DEVIATION REQUEST (Attach diagrams, figures, and other documentation to clarify request)

A deviation from the standards of or in Section **ECM section 2.2.4 Roadway Functional Classifications** of the Engineering Criteria Manual (ECM) is requested for the Sterling Ranch Road Right of Way and cross section.

TYPICAL SECTION
 STERLING RANCH ROAD ROAD
 STERLING RANCH FIL 2
 JOB NO. 2518801
 SEP. 14, 2020
 SHEET 1 OF 1

SECTION D
STA 7+14 TO STA 8+71
 SCALE: NTS

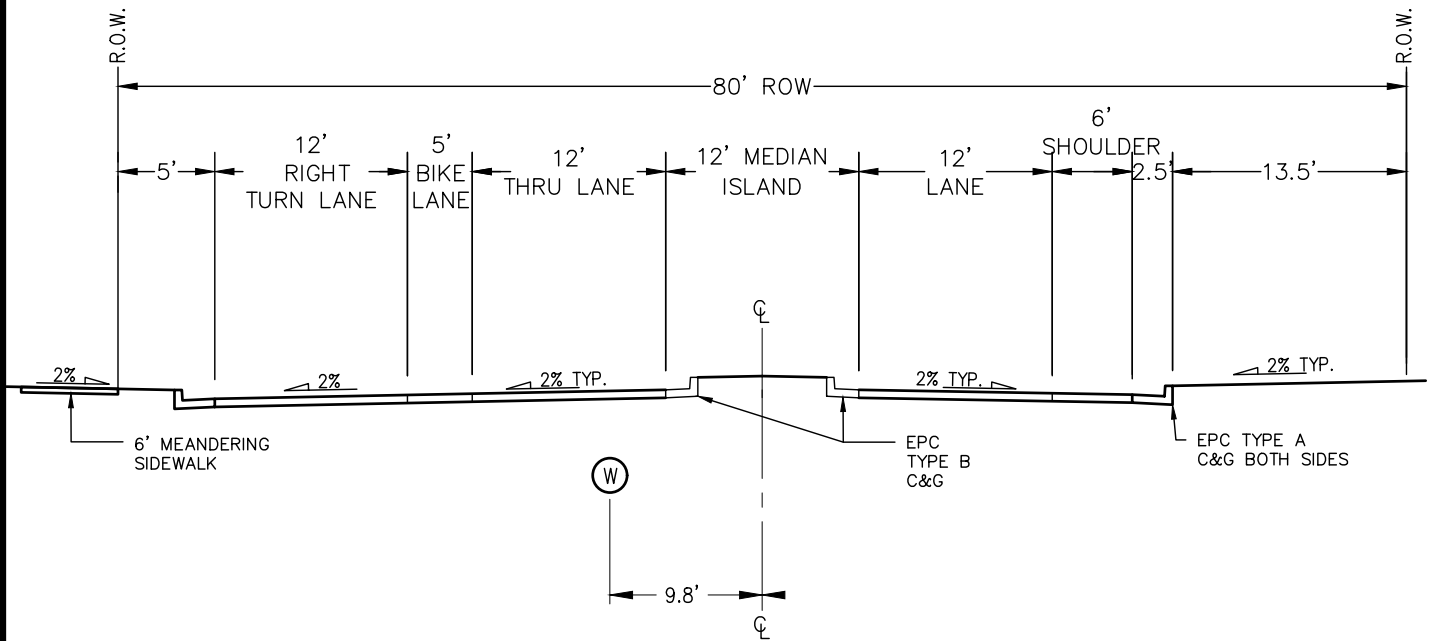
To the east of Bynum Drive, the ROW will be 80 ft but the roadway cross section will include an 12 ft. wide raised median between station 7+14 to station 8+72. Minimum pavement widths will be maintained for the travel lanes and shoulders.

SECTION C
STA 4+60± TO STA 6+13
 SCALE: NTS

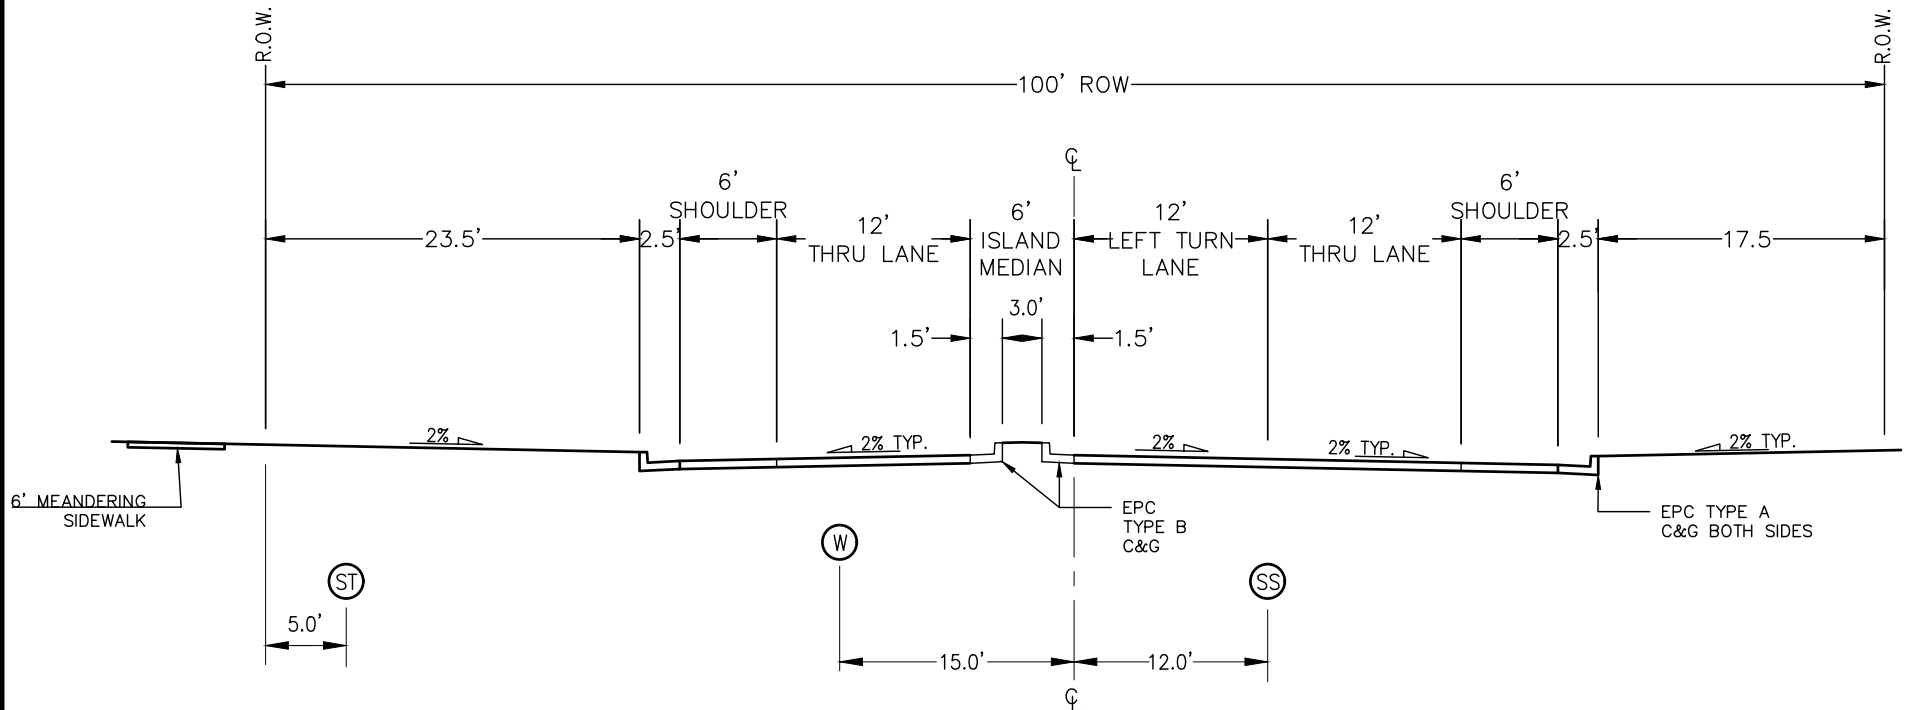
The applicant will provide a 100 foot wide right of way to allow for turning movements at .Marksheffel and Bynum Drive and transition to the standard 80 ft. ROW across the Bynum Drive Intersection..

SECTION A
STA 0+93 TO STA 2+31±
 SCALE: NTS

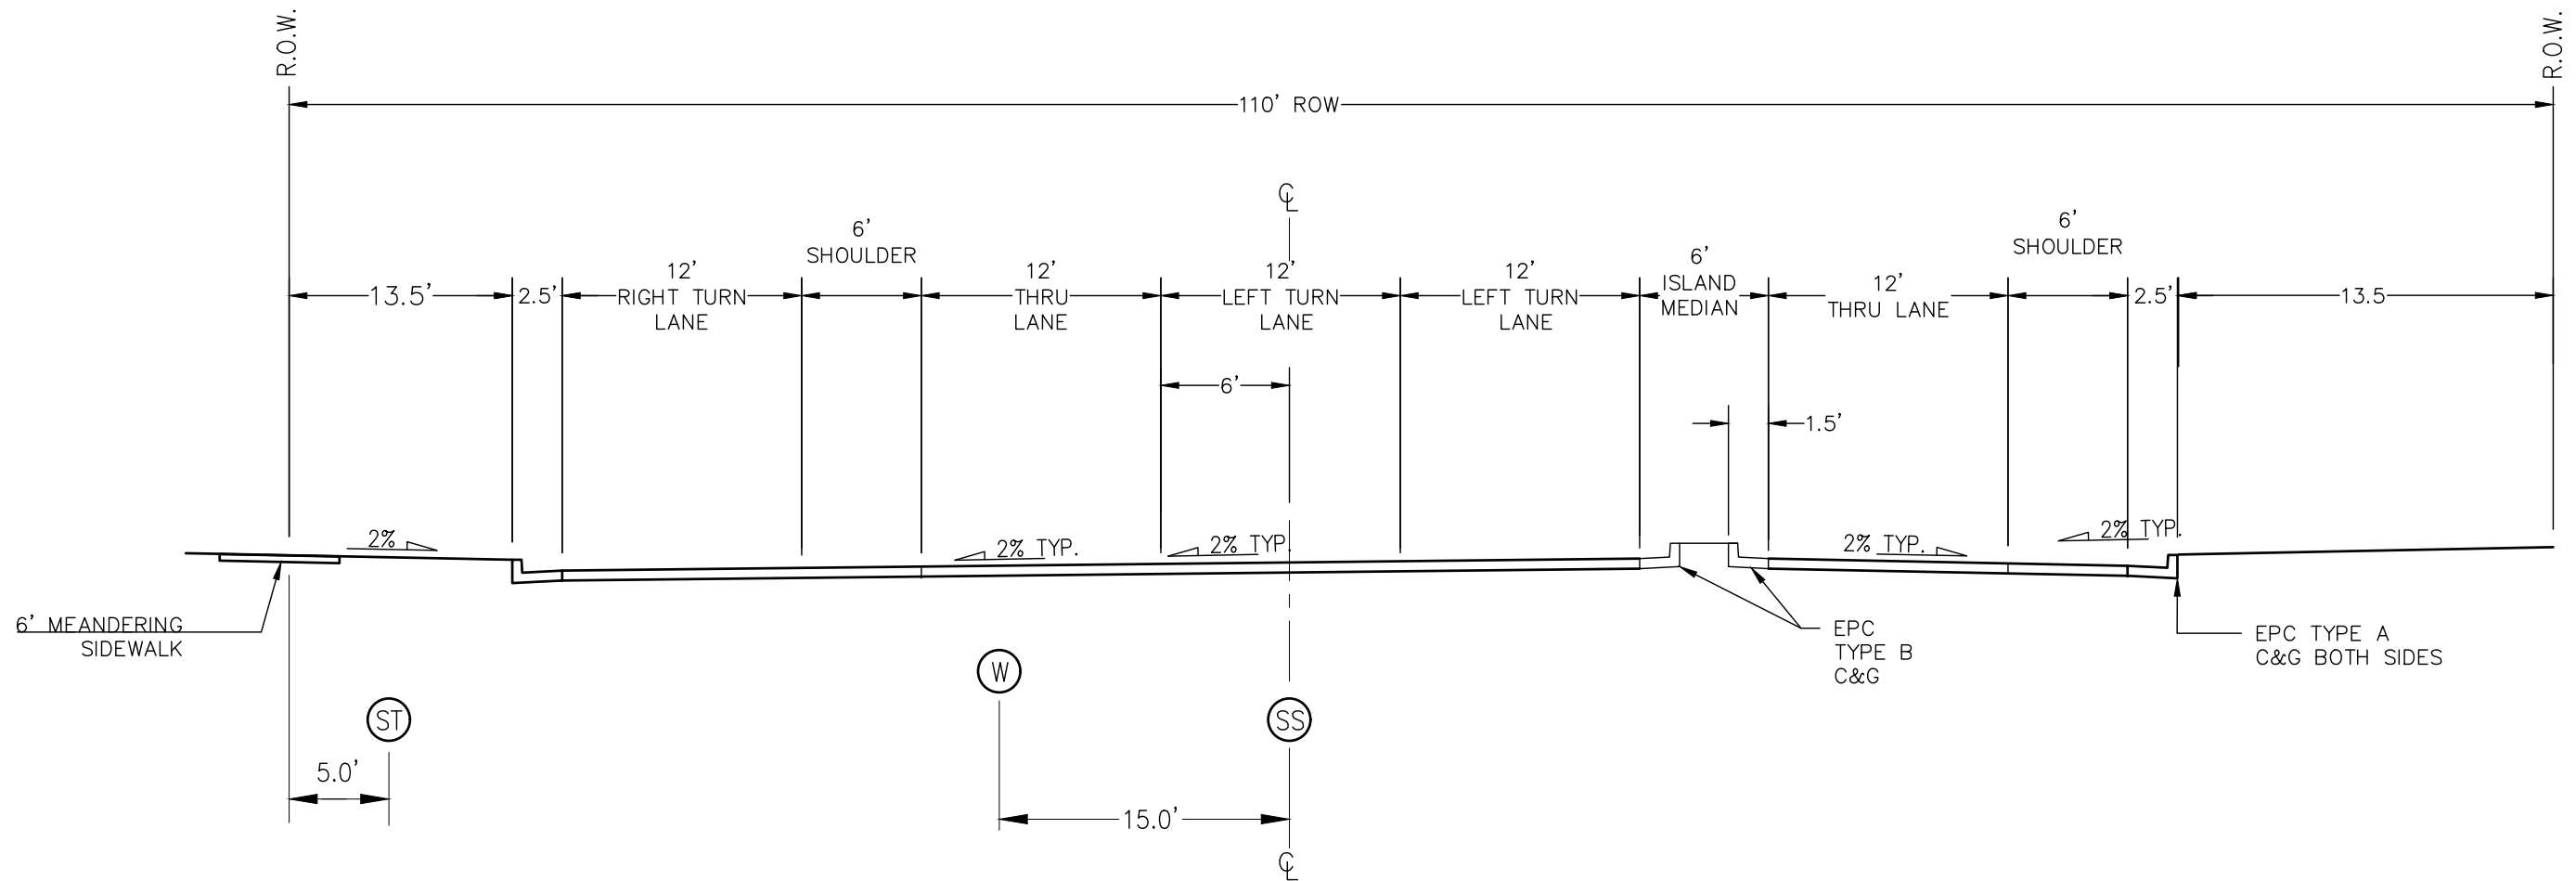
The applicant will provide a 110 foot wide right of way at the Sterling Ranch Rd/Marksheffel intersection to allow for turning movements onto Marksheffel.
